REFERENCE NO. 08/2014/1139/PF
IFOR WILLIAMS TRAILERS LTD
CYNWYD

PROPOSED SITE PLAN | 14 SPACES

PROPOSAL: Demolition of existing dwelling and construction of car parking area to serve adjacent factory, involving alterations to existing access, changes to levels, landscaping and associated works

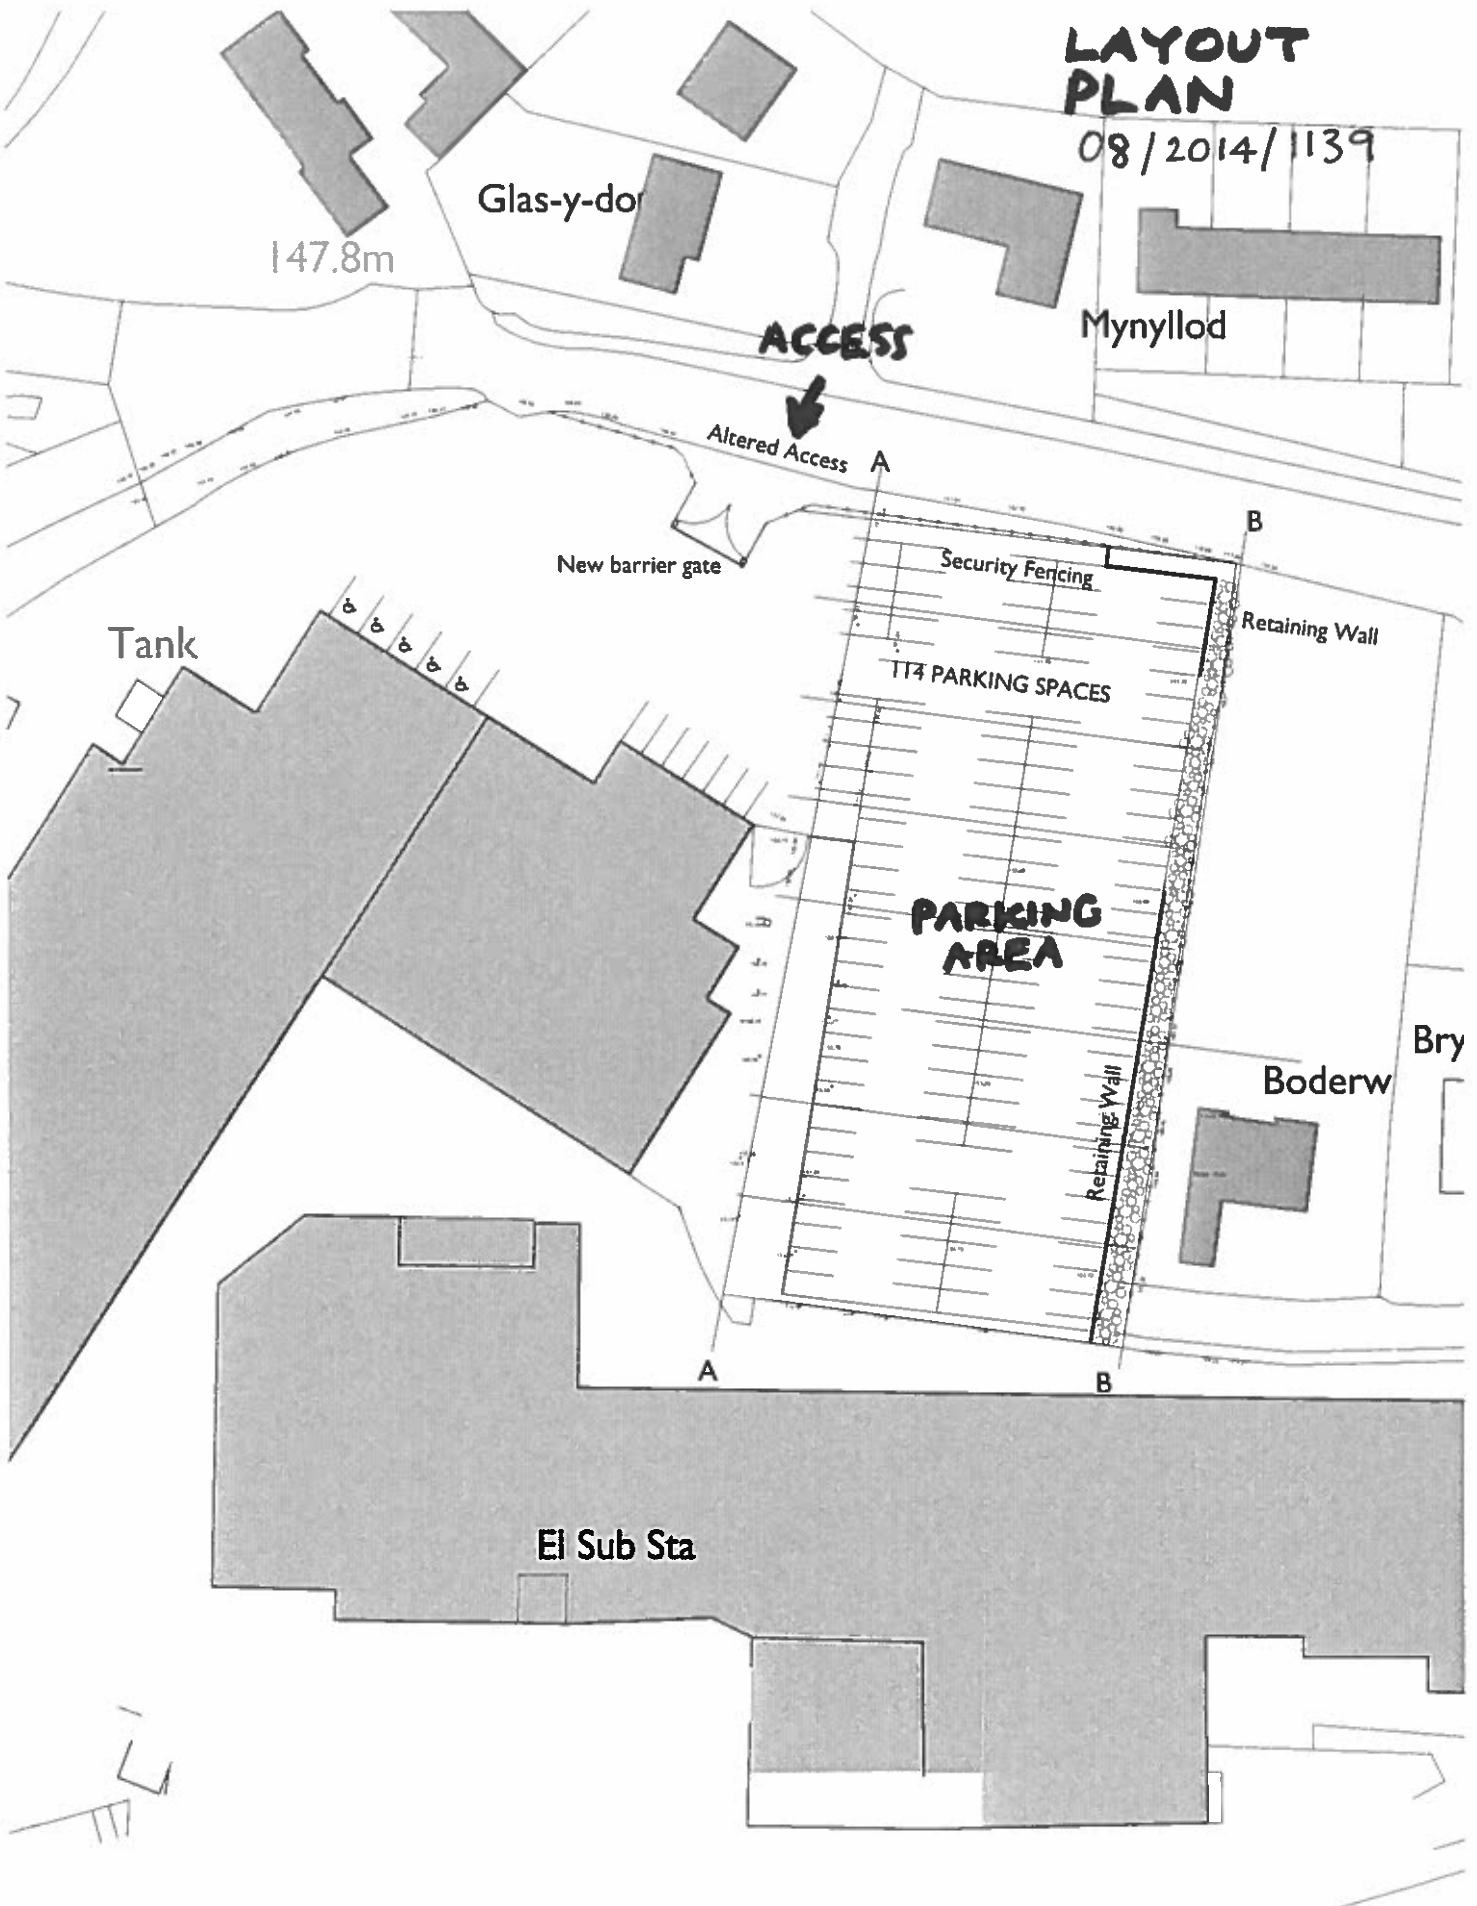
The proposals involve the clearance of some established natural features such as trees and hedgerows, and the introduction of retaining walls, alternative boundary planting of a yew hedge along the eastern boundary, and security fencing along the northern boundary. There are concerns expressed over the detailing in relation to the visual impact of black steel fencing, in terms of effect on the outlook of a nearby dwelling, and there is uncertainty over the impact of the proposed retaining wall in the absence of any detail in the submission.

Officer's view on this matter is that it is unfortunate that the proposals oblige the removal of established vegetation, but most of this is inevitable if the number of parking spaces are to be created. The comments of local residents are nonetheless to be respected and it is considered that the plans as submitted do not show a suitable degree of sensitivity to the location and require reassessing to provide basic mitigation of the visual impact of the development. If a permission is to be considered, it is suggested that the detailing all the boundary treatment including fencing, walls and planting should be subject to conditions requiring the submission of alternative / full details to minimise the effects of the development on neighbours and the locality. It will also be important to oblige submission of lighting details given the proximity to residential properties, as the visual impact of lights over an area of this size could be significant.

There are local concerns expressed over potential for loss of residential amenity from the proposed parking area, by way of increased noise and disturbance and loss of privacy. There are specific concerns over the potential for disturbance at antisocial hours. A separate concern has been noted if the parking area is to be used by articulated lorries. The Pollution Control Officer has no objection in principle to the development but has requested further details of hours of operation, dust and noise mitigation measures, and the lighting scheme. He

has questioned the removal of a noise attenuating barrier from the scheme and suggests that it may be necessary for such a barrier to be installed.

The plans show the intention to provide a marked out parking area and to improve the existing entrance into the site off the main approach road. There are local concerns over the highway implications of the development in terms of additional traffic on a road used by the village school, a question from an individual as to whether the entrance is in the most appropriate location, and a suggestion that there may be conflicts with school traffic on Friday afternoons. There is concern if articulated lorries use the parking area. The Community Council have requested the developer contributes to a 20mph sign proposed near the school, to assist efforts at slowing traffic on the approach road. The Highway Officer has no objections to the proposal.

2. **PRE-COMMENCEMENT CONDITION**
Notwithstanding the submitted details, no development shall be permitted to commence on the retaining walls, the proposed security fencing, or any other boundary fencing and planting until the written approval of the Local Planning Authority has been obtained to the detailing thereof. The development shall be carried out strictly in accordance with the detailing approved under this condition.

4. Notwithstanding the submitted details, the parking area shall not be brought into operation until the written approval of the Local Planning Authority has been obtained to the detailing of a scheme of noise mitigation / attenuation along the boundary with Bod Erw, and the approved scheme has been implemented in its entirety. The scheme shall be retained in place as approved at all times.

8. Notwithstanding the submitted details, no external lighting shall be permitted without the formal written approval of the local planning authority to the detailing of the proposed lighting (including the type, the means and extent of lamination and anticipated spread of light). The scheme shall be implemented strictly in accordance with the approved details.
